Evaluation of proposed move for Water Right No. 32975

Proposed: Add an additional well to water right no. 32975 a distance of 2,122 ft to the southwest of the current well location. This is the well location previously authorized under water right no. 32975 prior to a change in point of diversion in 2020.

Data Set: C:\Users\trevora\Documents\2021_Moves\32975\32975 Current.aqt
 Date: 04/21/21 Time: 16:48:46

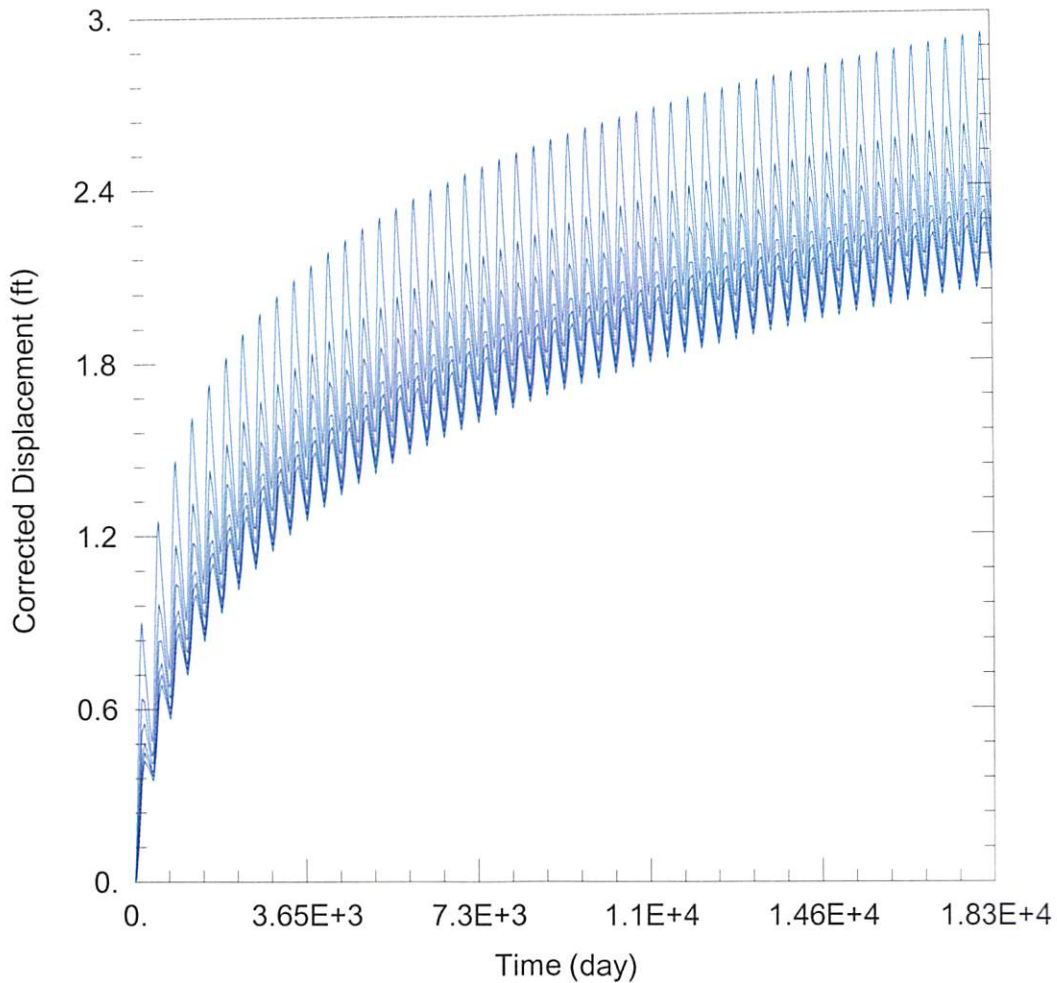
8097: Drawdown from current location = 2.62 ft
Drawdown from proposed location = 3.07 ft
Net drawdown = **0.4 ft**

19972: Drawdown from current location = 2.48 ft
Drawdown from proposed location = 3.85 ft
Net drawdown = **1.4 ft**

20741: Drawdown from current location = 2.31 ft
Drawdown from proposed location = 2.66 ft
Net drawdown = **0.4 ft**

Domestic 14-31-31: Drawdown from current location = 2.27 ft
Drawdown from proposed location = 2.79 ft
Net drawdown = **0.5 ft**

Domestic 13-31-31: Drawdown from current location = 2.93 ft
Drawdown from proposed location = 3.47 ft
Net drawdown = **0.5 ft**

Domestic 12-31-31: Drawdown from current location = 2.35 ft
Drawdown from proposed location = 3.12 ft
Net drawdown = **0.8 ft**

Net drawdown does not exceed the drawdown allowance of 3.5 ft for any well within 1 mile of the proposed location. Therefore, critical well analysis is not necessary.

The proposed move is likely to create minimal effects on neighboring wells and is unlikely to cause impairment. GMD3 staff recommends approval of this proposal.
